STAFF RECOMMENDATION

945 S Douglas Avenue, Unit #1

January 20, 2021

Application: New Construction – Infill/Part II SP

Figure 4. North side elevation

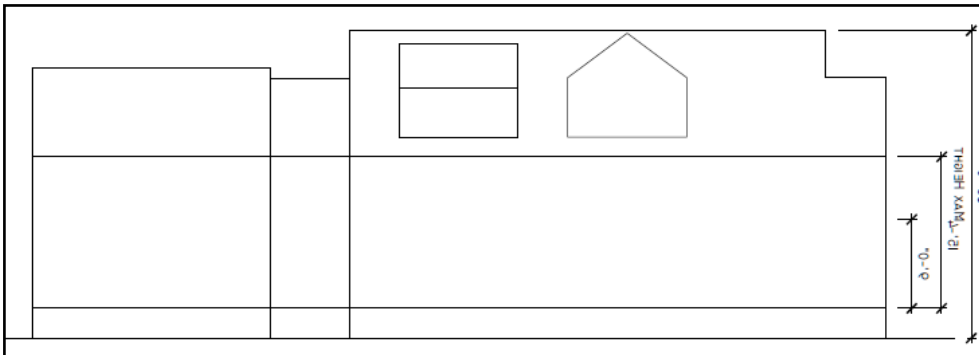
Proportion and Rhythm of Openings: The windows on the proposed infill are generally twice as tall as they are wide, thereby meeting the historic proportions of openings. There are two horizontal windows on the north side elevation (Figure 4) and two square windows on the front elevation (Figure 2). Staff finds that these windows could be appropriate as they are accent windows, not the dominant window type. Further, the horizontal windows are located well back on the side elevation. There are no large

Figure 5. Massing study from Part I SP application

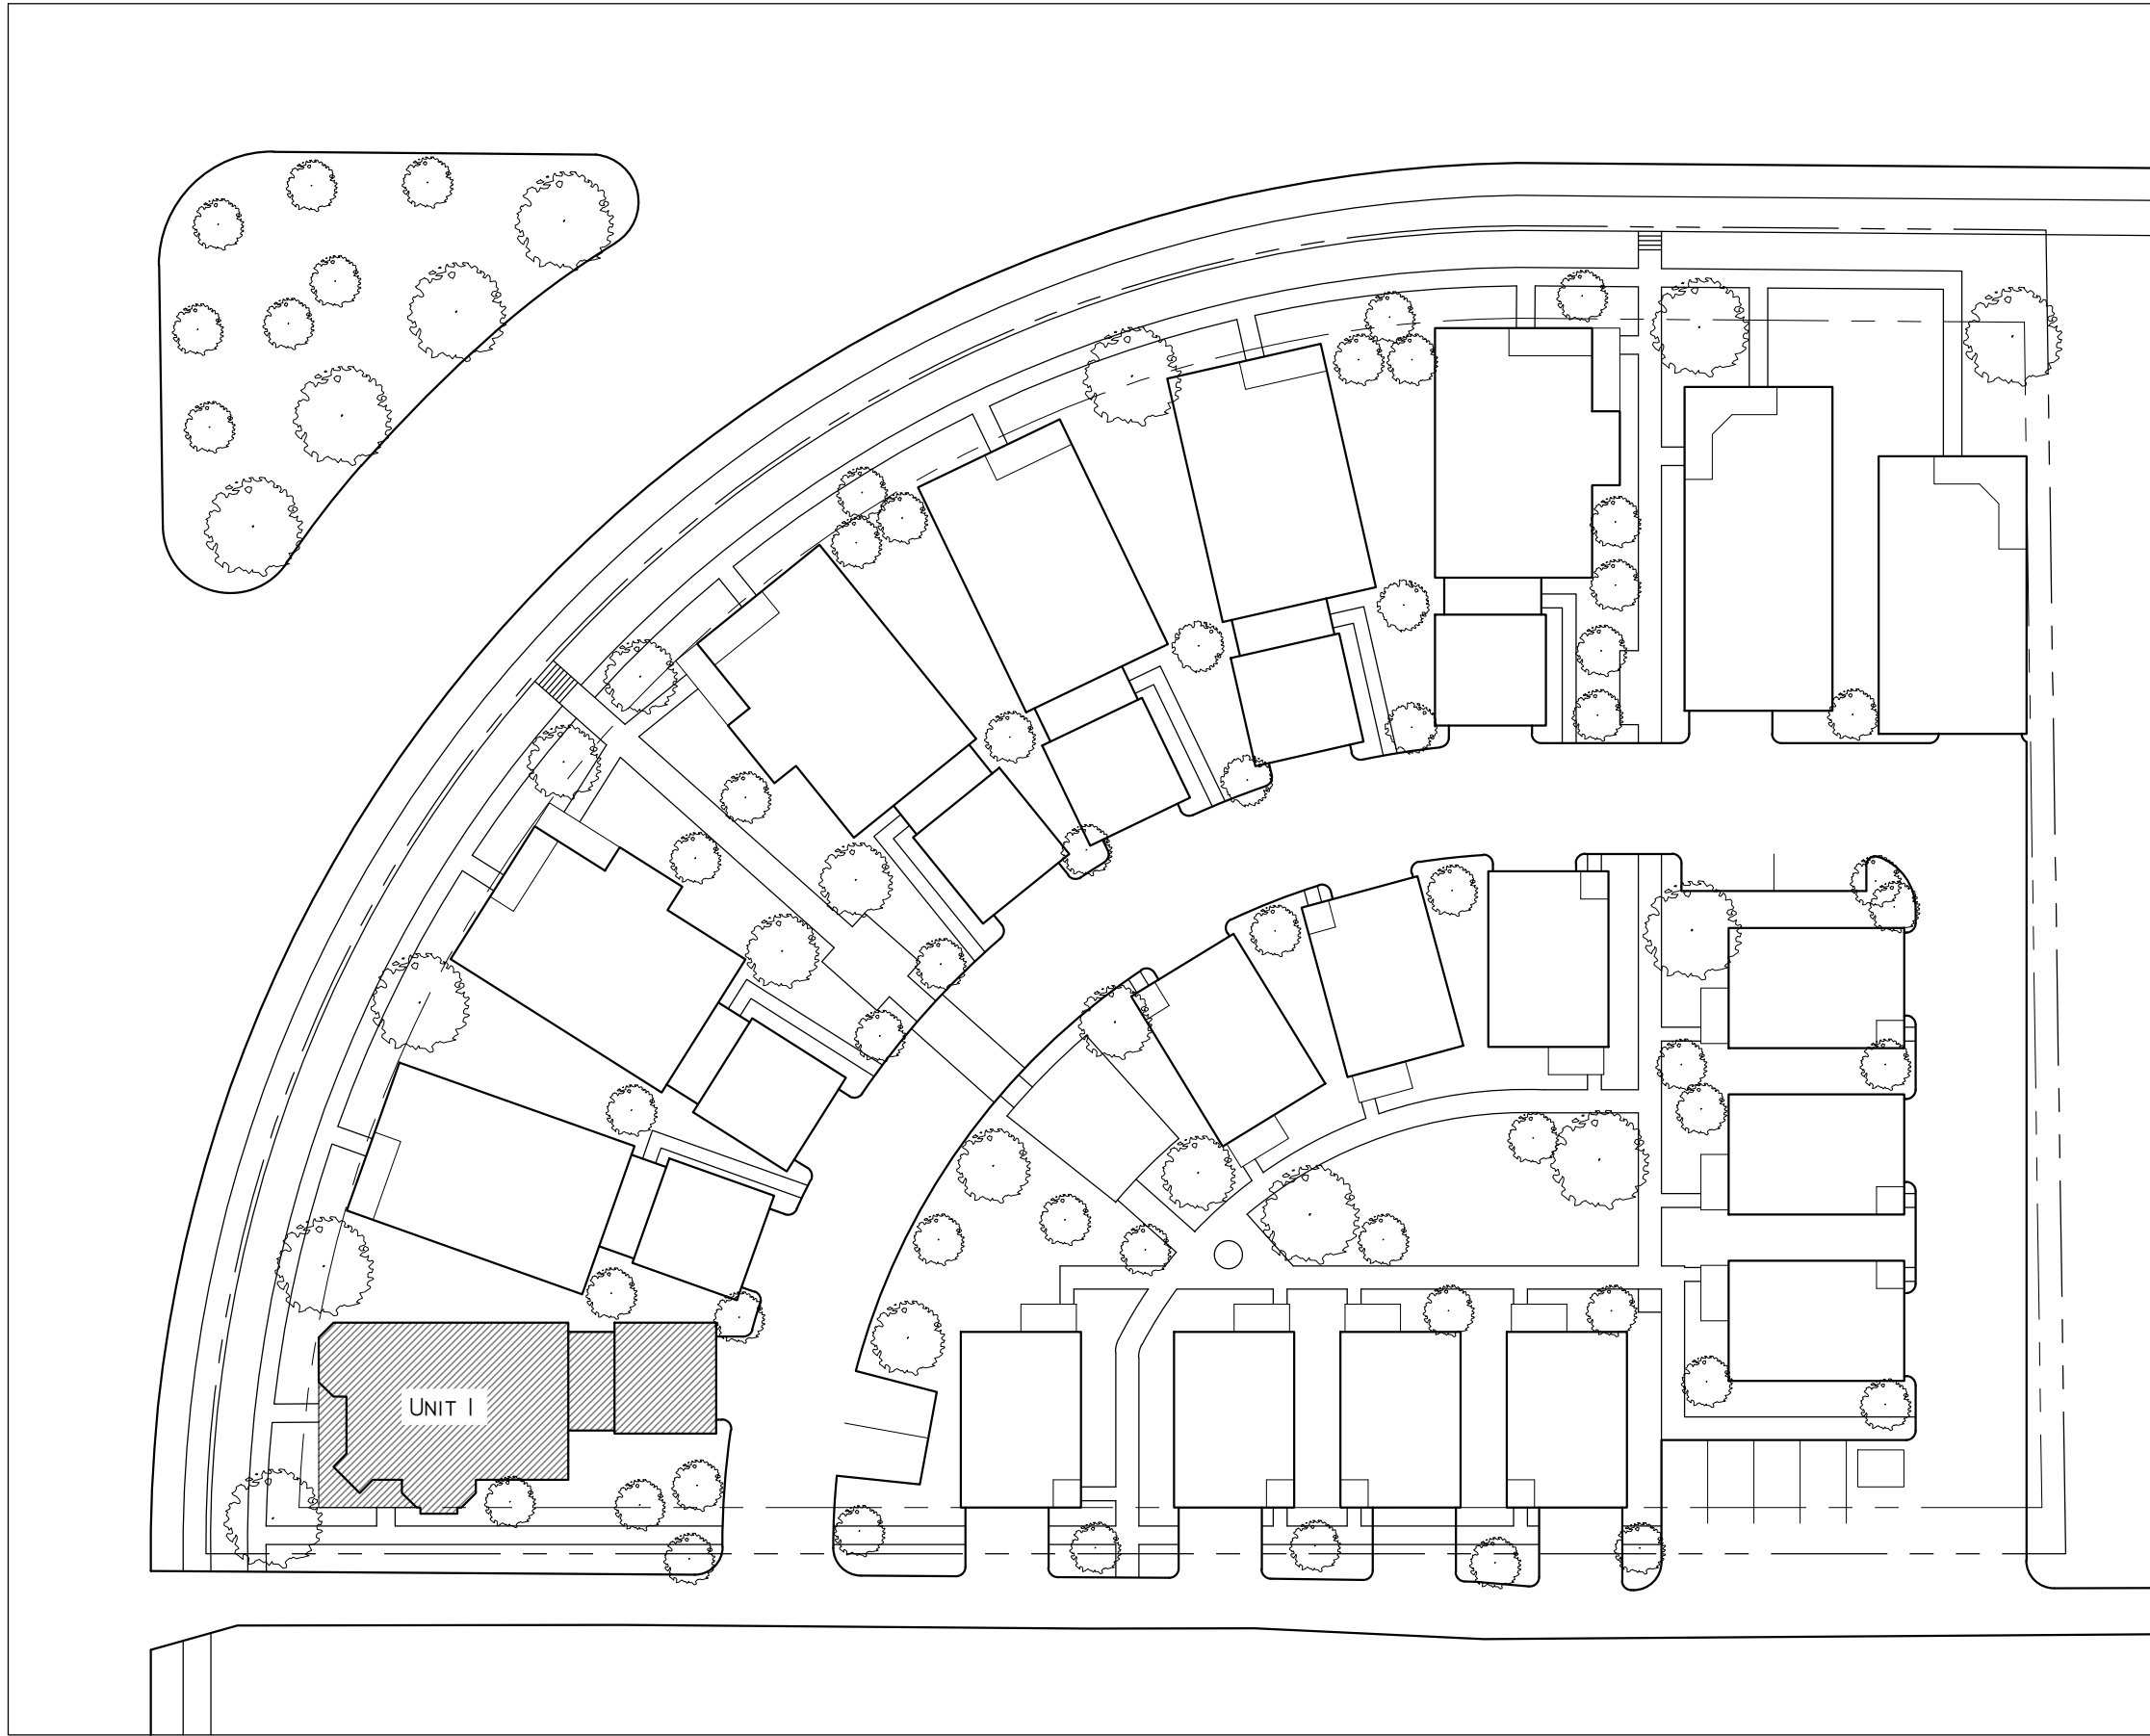
Outbuildings: As per the approved SP, all nineteen (19) of the houses in this project will include an attached garage accessed off of the rear private drive. The massing studies from the part I SP application show the attached garages for the thirty-five foot (35') tall one-and-a-half story units #1-#7 as subservient in height with a ridge height of approximately twenty-seven feet (27') from grade and an eave of fifteen feet, four inches (15'4") from foundation. (Figure 5) The proposed attached garage is a full two stories with a ridge height of about thirty-two feet (32') from grade and an eave of nineteen feet, eight inches (19'8"). While the Commission approved Unit 1 as a maximum two-story structure, the ridge height was not increased. The garage height should remain at approximately twenty-seven feet (27') and its connector should be below the ridge line.

Staff finds that the proposed attached garage is inconsistent with the massing and site plan of the approved SP.

PROPOSED SITE PLAN

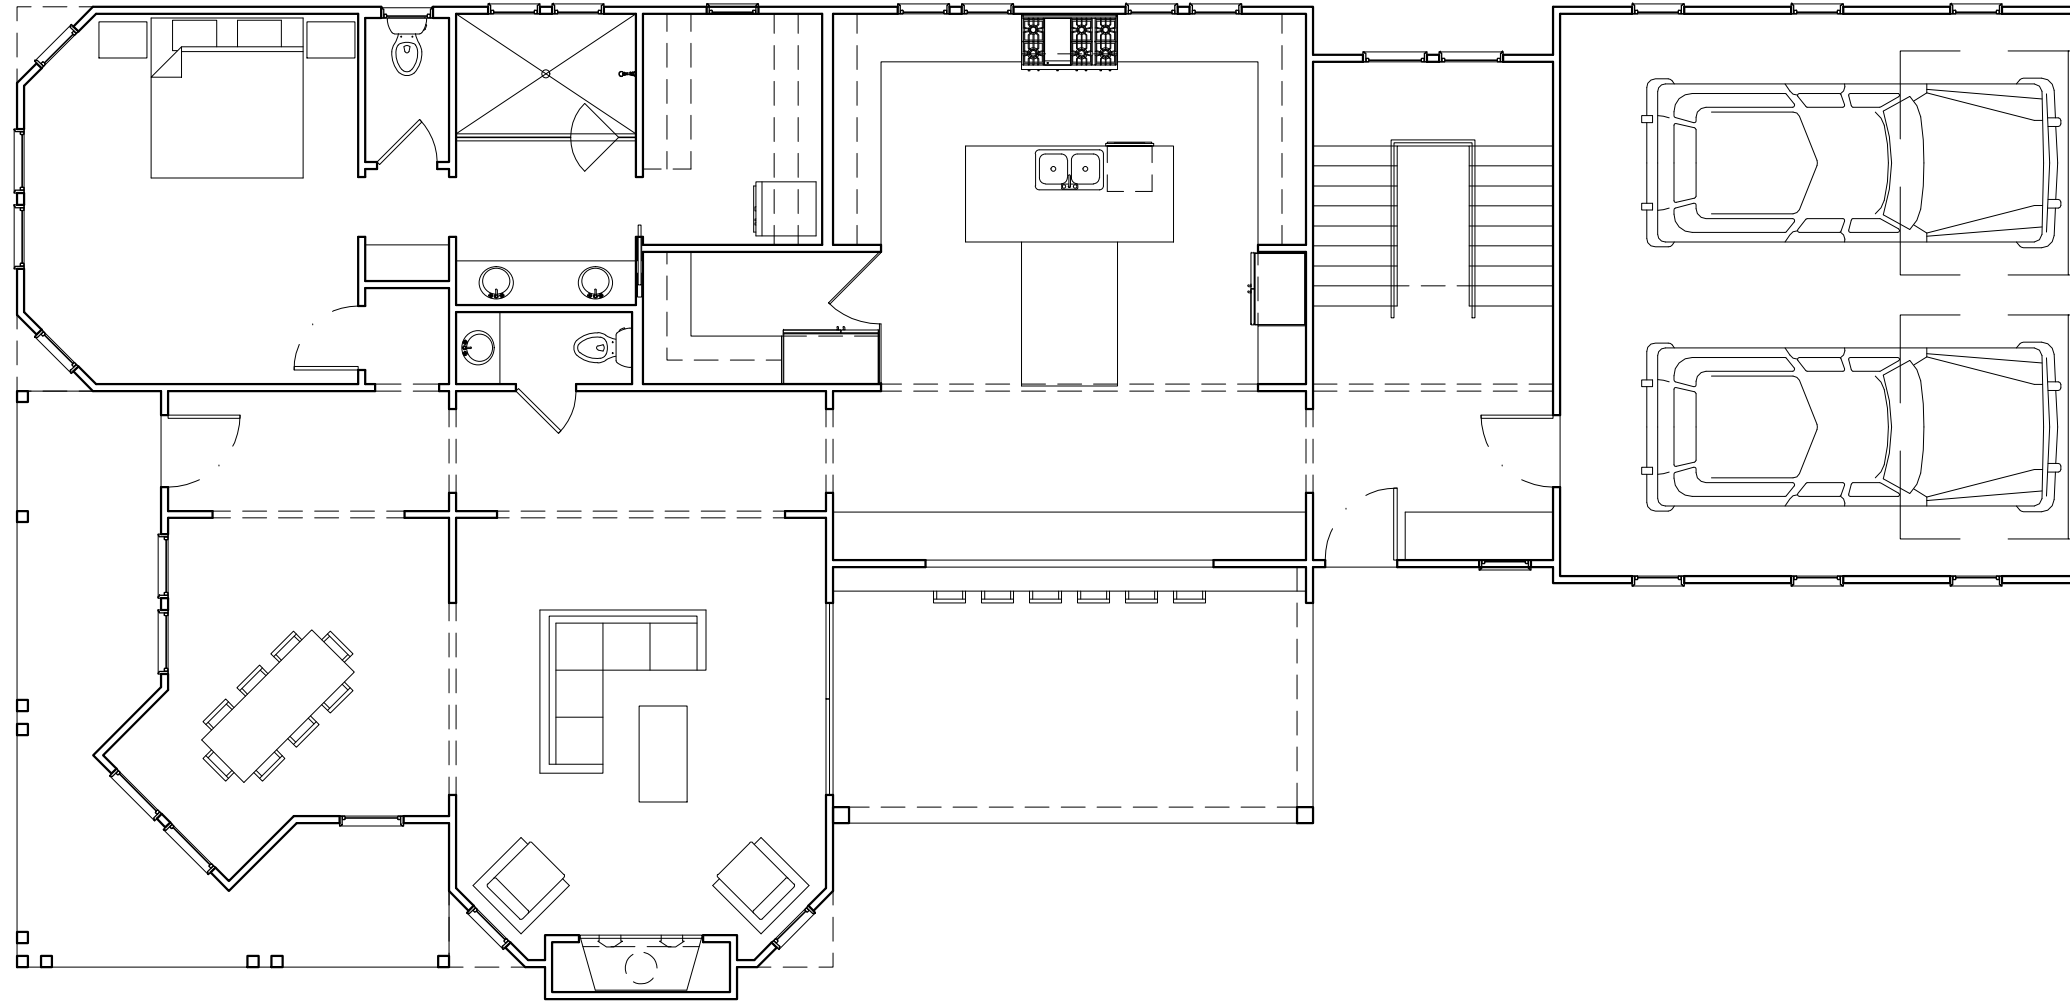
Setback & Rhythm of Spacing: The infill will be sited as per the approved part I SP. This house will have a twenty-foot (20') front setback, as will the next six (6) houses along this street face. These houses will all be about twenty-five feet (25') apart at the

front and will come closer further back, due to the curve of the parcel. Most will still maintain a distance of about ten feet (10'), but Unit #1 and Unit #2 will come a bit closer and will be about five feet (5') apart at the back corner. This condition was present in the part I SP and was approved. The right side of Unit 1 is next to the alley which will be used to provide access to the interior units. It sits about nine feet (9') from this property line, as approved.
